Elevation Motors Need Bushings Too

ACURA ServiceNews

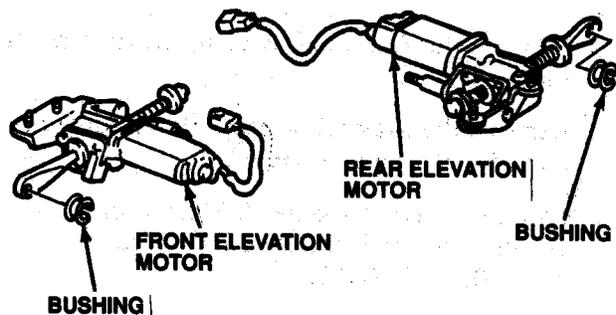
As thorough as the '91-92 Legend S/B 92-017, "Driver's Seat Rocks," is, it doesn't mention installing bushings on the front and rear elevation motor shaft ends. If you use the new link bolts from the kit without the bushings, the seat will rock more than it did before.

Luckily, the bushings are already included in the kit, and the S/B will be revised soon. In the meantime, make note on steps 11 and 20 to install the bushings before you install the new motors.

One last note, page 20-56 of the '93 Legend Sedan S/M clearly illustrates the best way to install and flare the split bushings used in this procedure.
